STATE OF CONNECTICUT  
CONNECTICUT SITING COUNCIL

IN RE: :  
 :  
APPLICATION OF HOMELAND TOWERS, : DOCKET NO. 473  
LLC AND CELLCO PARTNERSHIP D/B/A :  
VERIZON WIRELESS FOR A CERTIFICATE :  
OF ENVIRONMENTAL COMPATIBILITY AND :  
PUBLIC NEED FOR THE CONSTRUCTION, :  
MAINTENANCE AND OPERATION OF A :  
WIRELESS TELECOMMUNICATIONS :  
FACILITY AT 515 MOREHOUSE ROAD, :  
EASTON, CONNECTICUT : MAY 31, 2017

**RESPONSES OF HOMELAND TOWERS, LLC AND  
CELLCO PARTNERSHIP D/B/A VERIZON WIRELESS  
TO CONNECTICUT SITING COUNCIL PRE-HEARING INTERROGATORIES**

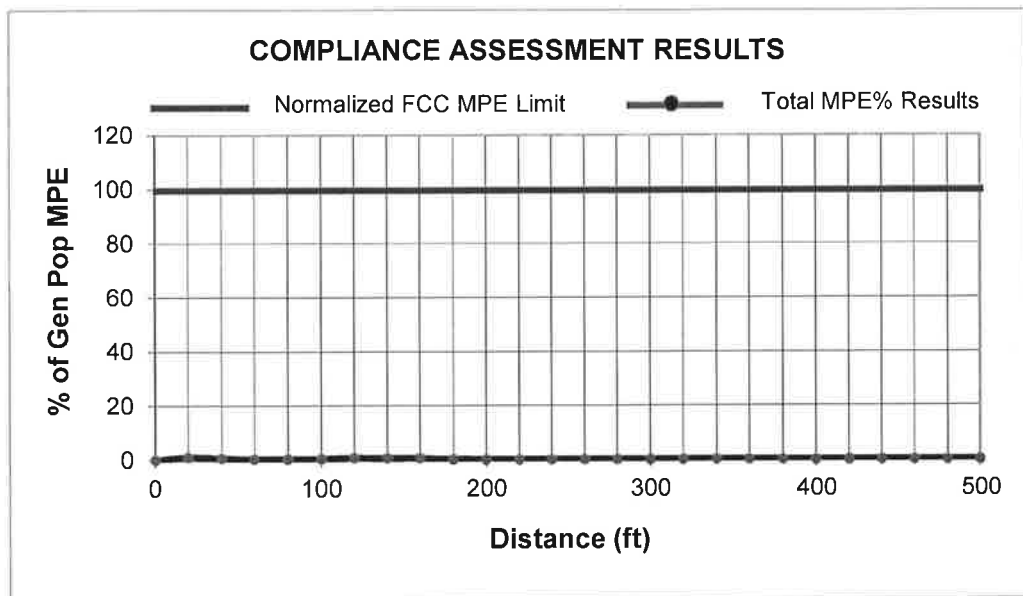
The power density analysis in Application Tab 14 does not have a value for the Town antenna located at a tower height of 95 feet above ground level. Please revise if necessary.

The power density analysis has been revised to include the value for the Town's microwave antenna located at a tower height of 95 and 150 feet. The conservatively calculated maximum RF emissions at street level from the assumed worst-case operations is 1.1176 percent of the FCC general population MPE limit. The revised analysis is included in an updated FCC compliance report by Pinnacle Telecom Group dated 5/31/17 and included in Attachment 2.

As indicated, the overall worst-case calculated result is 1.1176 percent of the FCC general population MPE limit – well below the 100-percent reference for compliance, particularly given the significant conservatism incorporated in the analysis.

A graph of the overall calculation results, shown below, provides perhaps a clearer *visual* illustration of the relative compliance of the calculated RF levels. The line representing the overall MPE% results barely rises above the graph's baseline, and shows a consistent, comfortable margin to the FCC MPE limit.

# Avian Resources Map

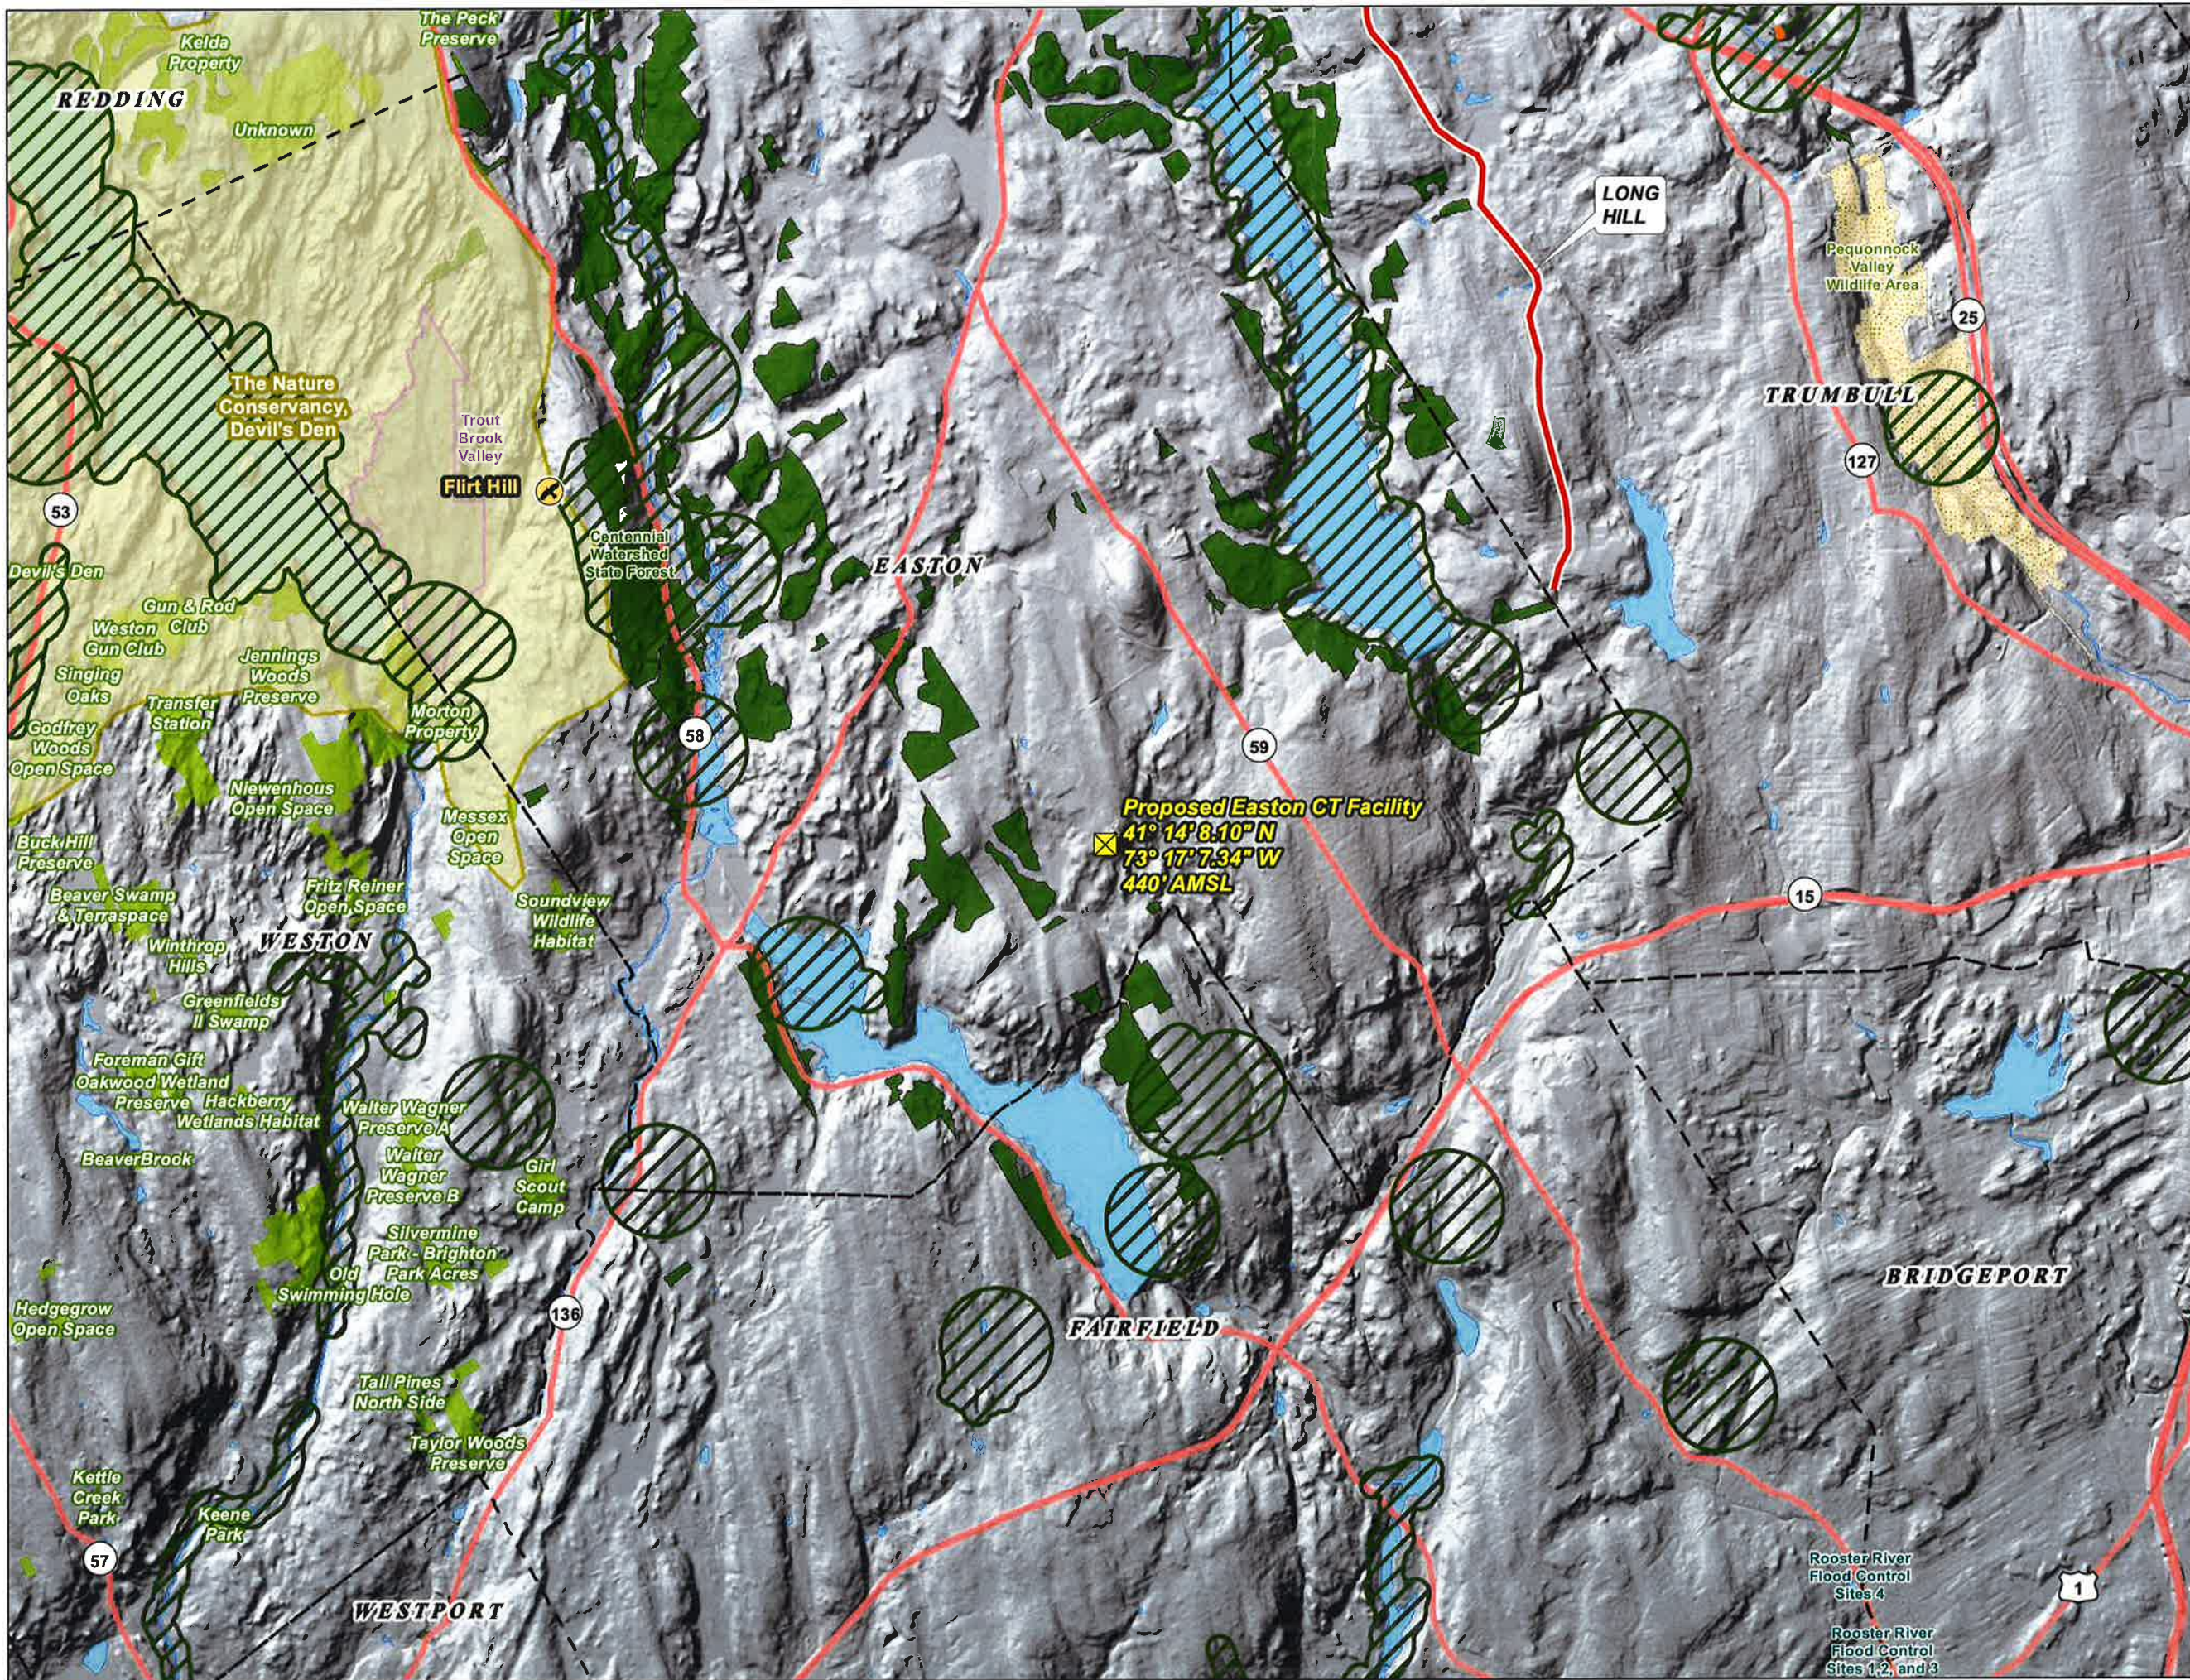
What is the distance/direction to the nearest National Audubon Society designated Important Bird Area?

The closest Important Bird Area (“IBA”) to the site is The Nature Conservancy’s Devil’s Den Preserve in Easton located approximately 2.25 miles to the northwest. This preserve is The Nature Conservancy's largest contiguous preserve in Connecticut, and is part of the largest tract of protected land located in the towns of Easton, Weston, Redding and Wilton in densely

developed Fairfield County. Devil's Den supports large populations of all of Connecticut's forest interior nesting bird species. Due to the significant distance separating the proposed facility from this IBA, no adverse impact to this resource or the bird species it supports are anticipated by the proposed development. Please see the Avian Resources Map provided as Attachment 3 for additional information.
